Q1 Please view the path alignment options at the Atwood Ave project page and then rate your support for each option. The project alignment options are on the project page under "March 2022 Proposed Path Alignments." Please note that Option 2 would not be cleared in the winter but Options 1, 3 and 4 would be cleared.

Atwood Ave Project - Olbrich Park Path Input

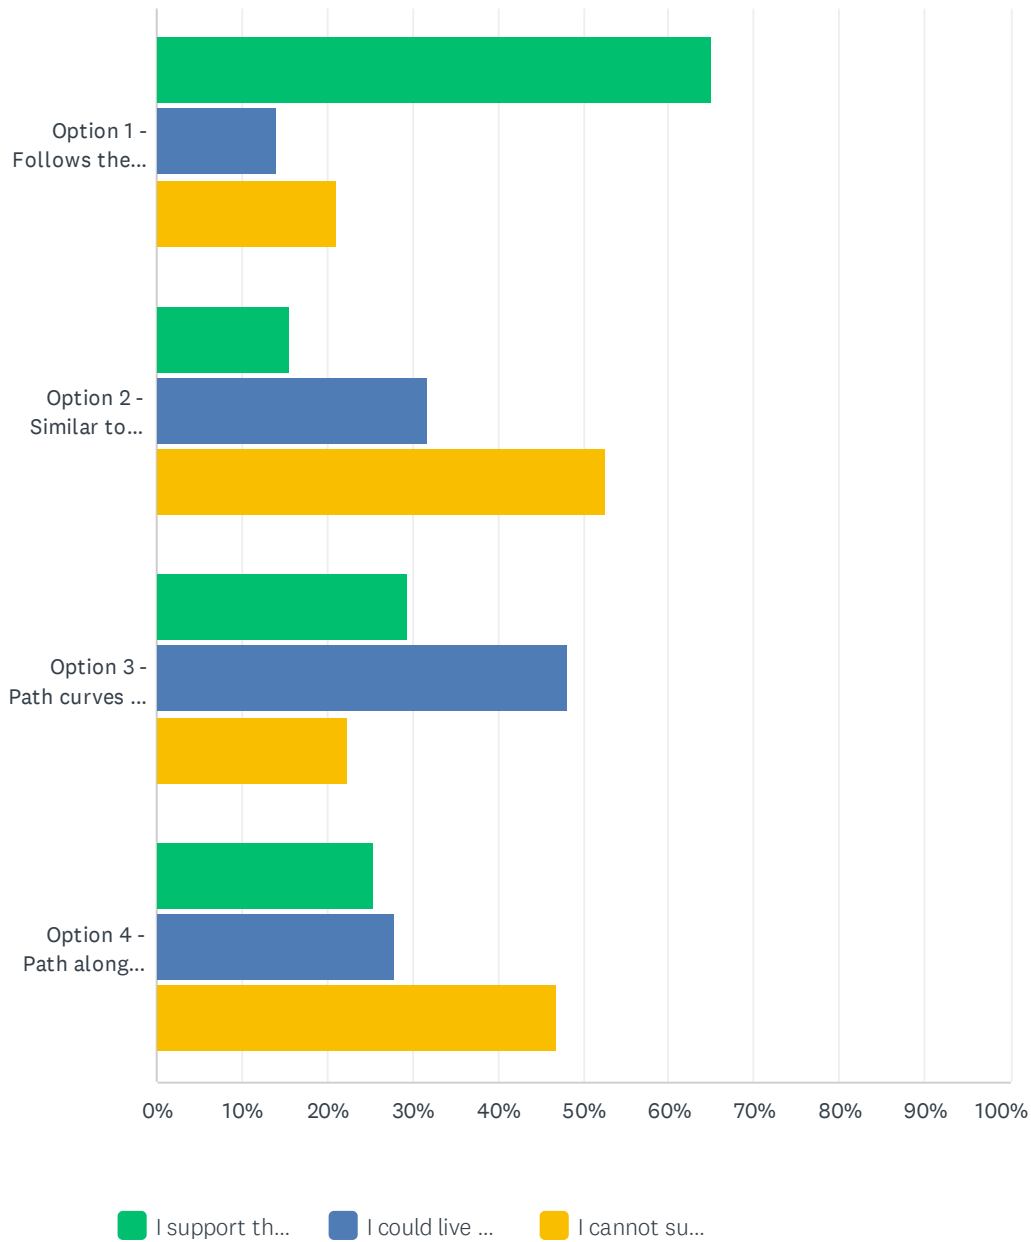
I SUPPORT THIS OPTION	I COULD LIVE WITH THIS OPTION	I CANNOT SUPPORT THIS OPTION	TOTAL	WEIGHTED AVERAGE
Option 1 - Follows the park lakeshore more closely	64.97% 306	14.01% 66	21.02% 99	471	1.56
Option 2 - Similar to current route	15.54% 71	31.73% 145	52.74% 241	457	2.37
Option 3 - Path curves to avoid sledding hill	29.45% 134	48.13% 219	22.42% 102	455	1.93
Option 4 - Path along Welch Ave & Oakridge Ave	25.27% 117	27.86% 129	46.87% 217	463	2.22

Q3 What width or path design would you prefer?

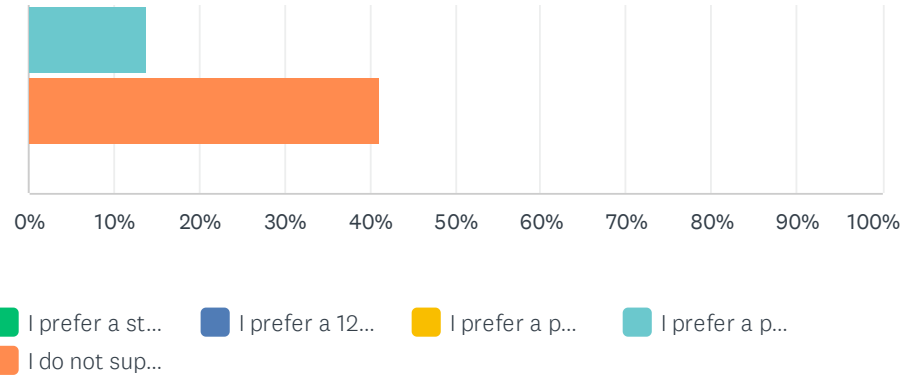
I PREFER A STANDARD 10 FEET WIDE SHARED PATH.	I PREFER A 12 FEET WIDE SHARED PATH.	I PREFER A PATH WITH 10 FEET FOR BIKING AND 5 FEET FOR WALKING.	I PREFER A PATH WITH 10 FEET FOR BIKING AND 7 FEET FOR WALKING.	I DO NOT SUPPORT THIS OPTION EVEN WITH A DIFFERENT WIDTH OR PATH DESIGN.	TOTAL	WEIGHTED AVERAGE
Option Three	13.62% 58	19.25% 82	23.71% 101	23.47% 100	19.95% 85	426	3.17
Option One	13.72% 62	13.72% 62	28.10% 127	25.88% 117	18.58% 84	452	3.22
Option Four	17.84% 76	10.56% 45	15.26% 65	16.90% 72	39.44% 168	426	3.50
Option Two	13.72% 59	12.09% 52	19.07% 82	13.95% 60	41.16% 177	430	3.57
